GOVERNMENT OF THE DISTRICT OF COLUMBIA
DEPARTMENT OF TRANSPORTATION

MEMORANDUM

SUBJECT: **BZA Case No. 19581** – 5000 14th Street NW (LAMB Charter School)

Figure 3. Vehicular Site Circulation – Interim Conditions (Source: Gorove/Slade, 9/5/17 CTR, Figure 7)

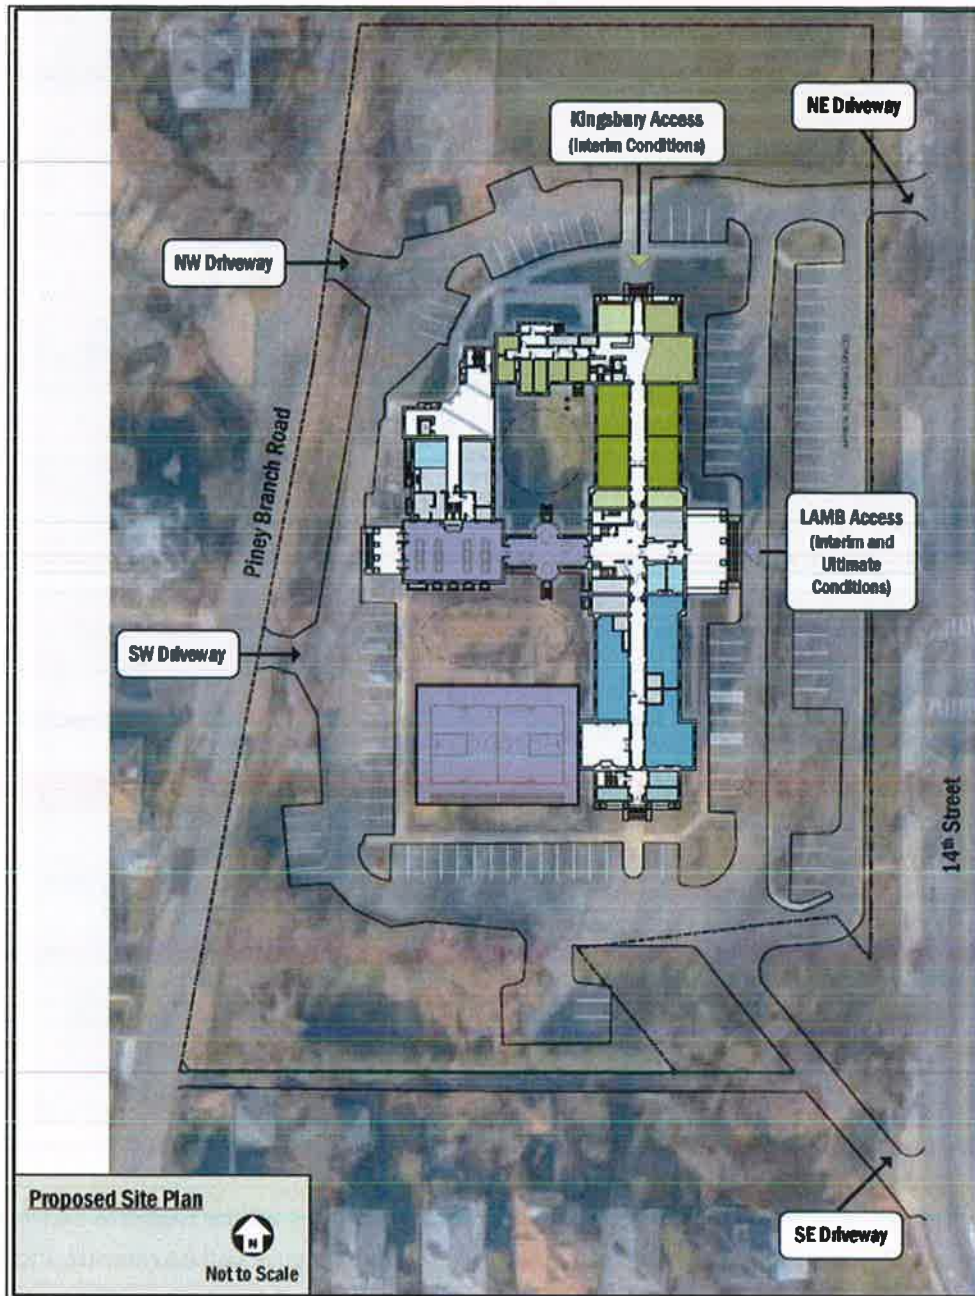
As part of the interim plan, the Kingsbury and LAMB school operations will be separate and so will their pick-up and drop-off operations. The primary Kingsbury building entrance will be relocated to the northern portion of the building (see Figure 2) and pick-up and drop-off operations will occur at the northern end of the site, as shown in Figure 3. During the interim stage, LAMB building access is proposed from the existing entrance on the east side of the building and pick-up/drop-off operations along the eastern side of the site.

Figure 8. Existing Pedestrian Facilities (Source: Gorove/Slade, 9/5/17 CTR, Figure 26)

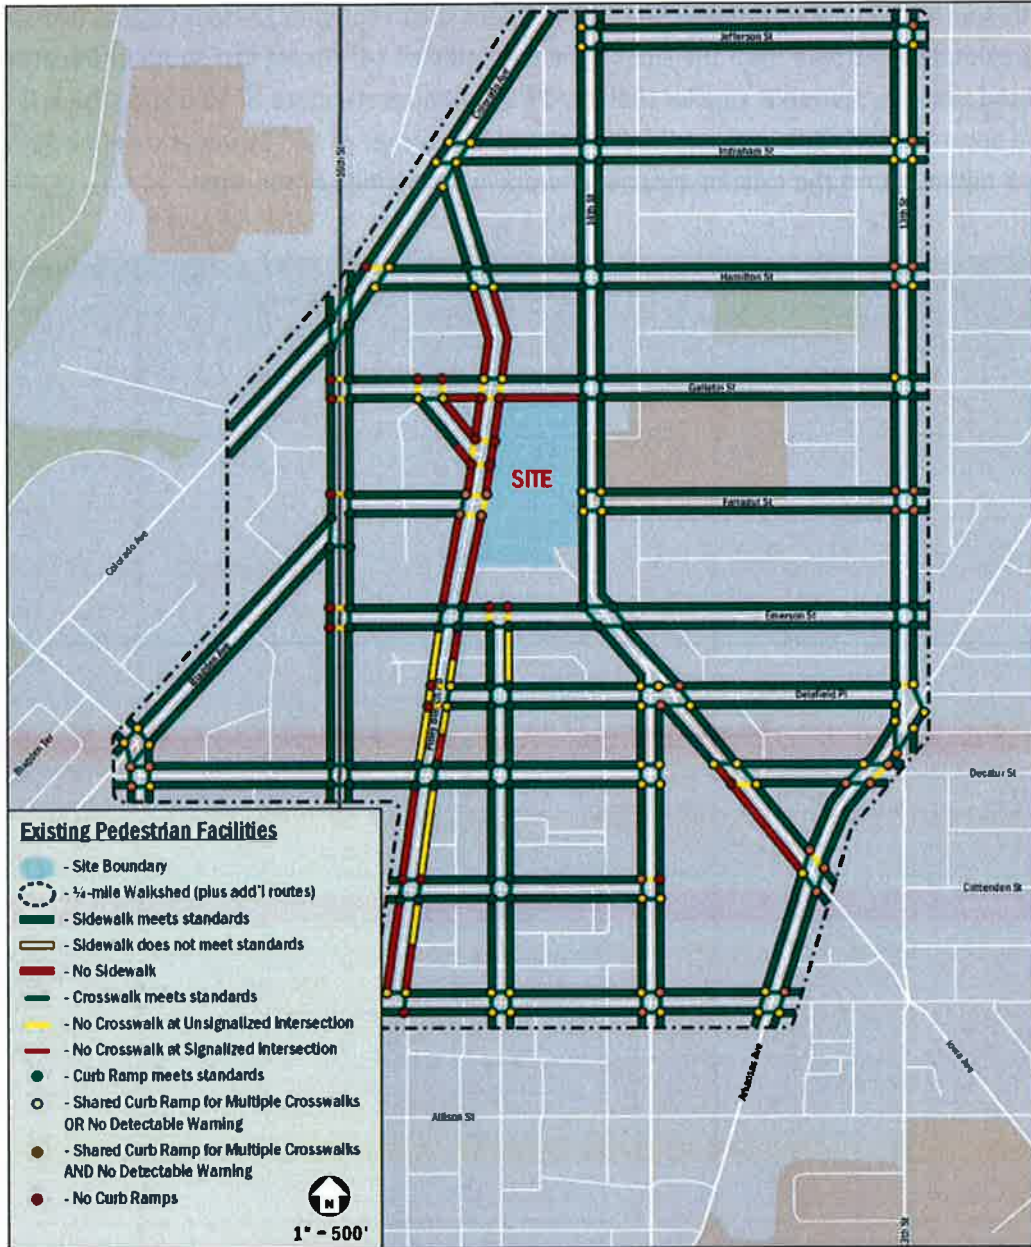
The Applicant performed an inventory of the pedestrian infrastructure in the vicinity and noted any substandard conditions. As shown below in Figure 8, there are several missing segments of sidewalk surrounding the site, particularly along Gallatin Street, Piney Branch, and Iowa Avenue NW. Additionally, there are missing or substandard curb ramps in several critical locations.

Sidewalks are not presently constructed along Piney Branch Road NW between Gallatin Street NW and Emerson Street NW due to right-of-way constraints. Currently, Piney Branch Road has approximately 25 feet of pavement within a 35-foot right-of-way including several fences and utility poles installed near the edge of pavement.

DDOT recommends the Applicant make the following improvements to the network to ensure and encourage safe pedestrian travel to the site:

- Fund and construct a sidewalk along the southern side of Gallatin Street between Piney Branch Road NW and 14th Street NW, with new curb ramps and crosswalks, as required, as well as crosswalks specifically across Gallatin Street at both Piney Branch Road and Iowa Avenue to connect pedestrians to the existing sidewalk on the northern side;
- Fund and construct new curb ramps on the northern and southern sides of Emerson Street at 15th Street NW and stripe crosswalks, subject to DDOT approval; and
- Fund and construct upgrades to all existing sub-standard curb ramps at the intersection of 14th Street and Farragut Street NW.
